# DEFENSE NUCLEAR FACILITIES SAFETY BOARD Staff Report

November 27, 2018

## Device Assembly Facility Seismic Hazard

Figure 1 – Comparison of horizontal and vertical response spectra derived from [3] and [4].

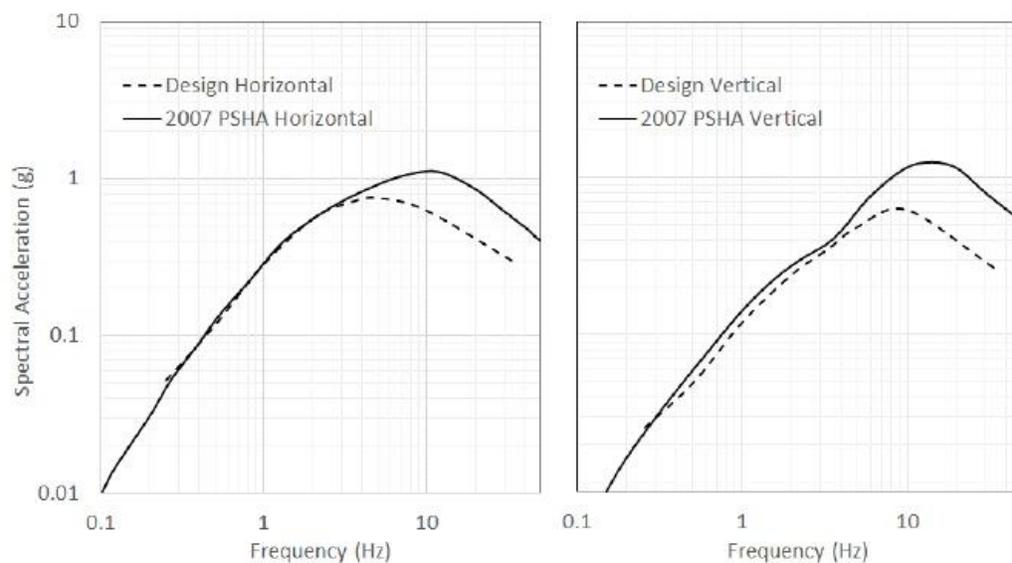
As part of the 10-year assessment of the seismic hazard, the previous site contractor, National Security Technologies, LLC (NSTec), analyzed the seismic hazard for DAF in 2007 using a probabilistic seismic hazard analysis (PSHA) approach. In the 2007 PSHA [3], the ground motion response spectra significantly exceeded the previous 1995 analysis [4] for the design-basis earthquake response spectra in a sensitive frequency range for safety-related structures, systems, and components (SSCs). Safety-related SSCs are generally sensitive to ground motion between 1 and 10 Hz. The horizontal ground motion spectrum in the 2007 PSHA exceeds the horizontal seismic design spectrum at 3 Hz and above. The vertical spectrum in the 2007 PSHA also exceeds the corresponding design spectrum for the same frequency range. A comparison between the 2007 PSHA and design basis response spectra is provided in Figure 1.
